RECEIPT DATE: 12/5/17 **ONSITE SEWAGE DISPOSAL SYSTEM** P 562349
 APPROVAL DATE: 1/19/18 **PERMIT: CONSTRUCTION** A _____
 PROPERTY ADDRESS: 11859 Lime Kiln Road
 SUBDIVISION: _____ LOT: _____ TAX ID: 05-342899
 CONTRACTOR: T & R Plumbing and Heating EMAIL: _____
 CONTRACTOR ADDRESS: P.O. Box 57, Lisbon, MD 21765 PHONE: 410-489-7776

RE: BAT Site Plan comments; 11859 Lime Kiln Road

RE: BAT Plan, 11859 Lime Kiln Road

Plan 630 A

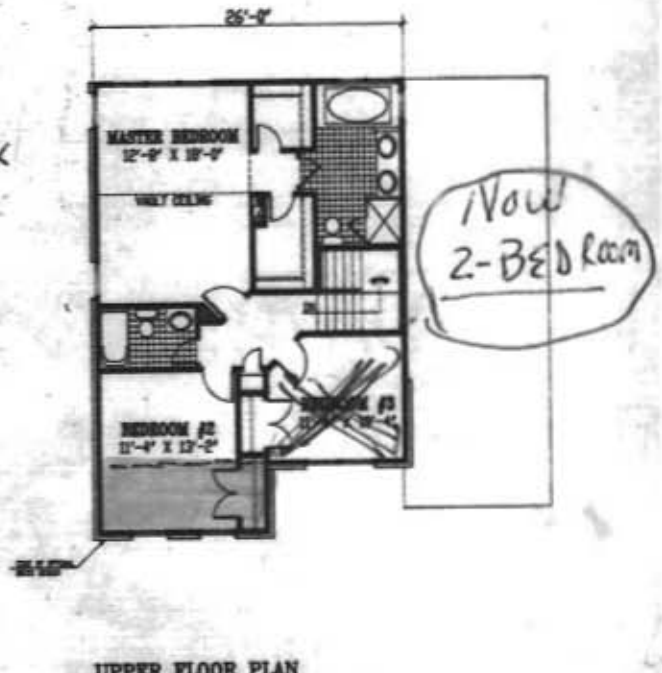
WAS 2002' Now 1734'

The proposal you sent to me appears to increase the square footage and living space compared to the existing. What you sent was a bit unclear, but is the existing basement finished or unfinished? You list the existing 1st and 2nd floor at 1320 sq ft. Your proposed house is 1734 sq ft not counting any basement (is there a basement and is it finished?). Any increase in square footage or living space or bedroom count would trigger the requirement for a sewage disposal area and this property does not have an approved sewage disposal area as long as the property at 8020 Hunterbrooke still has the existing downgrade well. An increase in living space or bedroom count would also trigger a requirement to upgrade the sewage disposal system with a BAT unit, which cannot happen until the disposal area is able to be used after the well at 8020 Hunterbrooke is relocated.
